Silicon Errata and Data Sheet Clarifications

The following typographic corrections and clarifications are to be noted for the latest version of the device data sheet (ww1.microchip.com/downloads/en/DeviceDoc/doc4383.pdf).

3.3.1 44-Lead TQFP (PT)

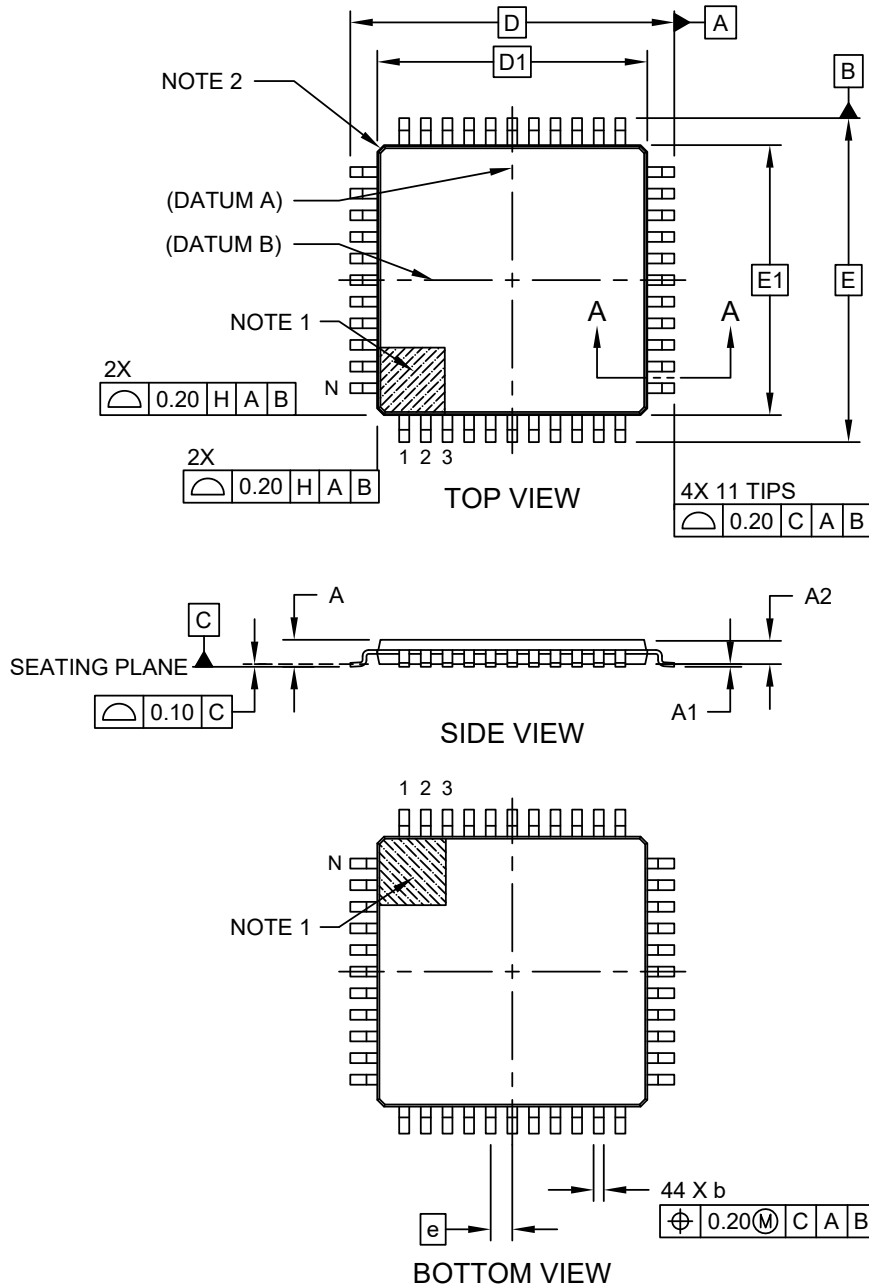
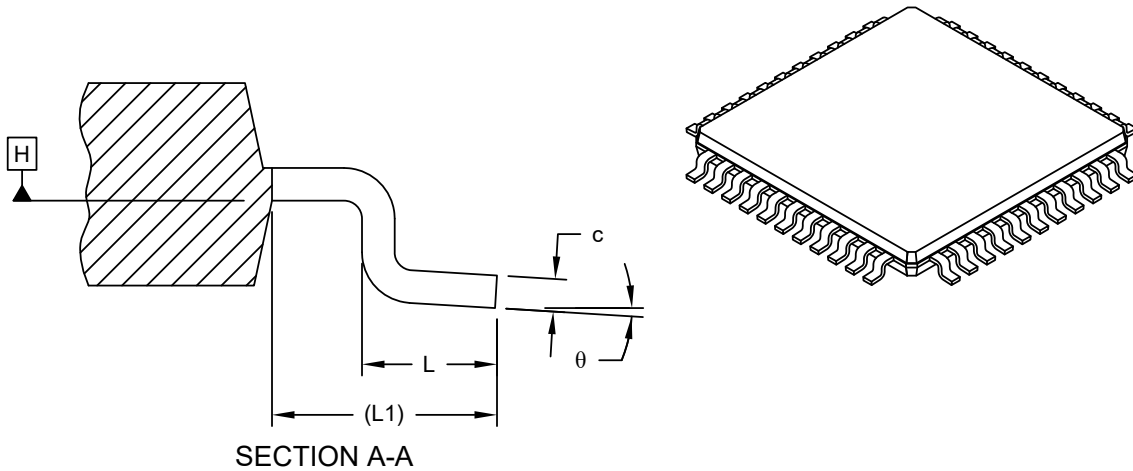
A clarification has been made to replace the VQFP package with a TQFP package.

A drop-in replaceable 44-lead TQFP with the same pinout, footprint, and based on the same die revision replaces the 44-lead VQFP package. There are no functional changes, hence all data sheet specifications are still valid for the replacement CPNs.

The TQFP package outline drawing is shown below.

EOL	Replacement
Package type	44-lead VQFP (LQFP)	44-lead TQFP
Package style	2FB (Atmel GPC: AYP)	PT
Package Outline Drawing (POD) number	C04-21003	C04-0076
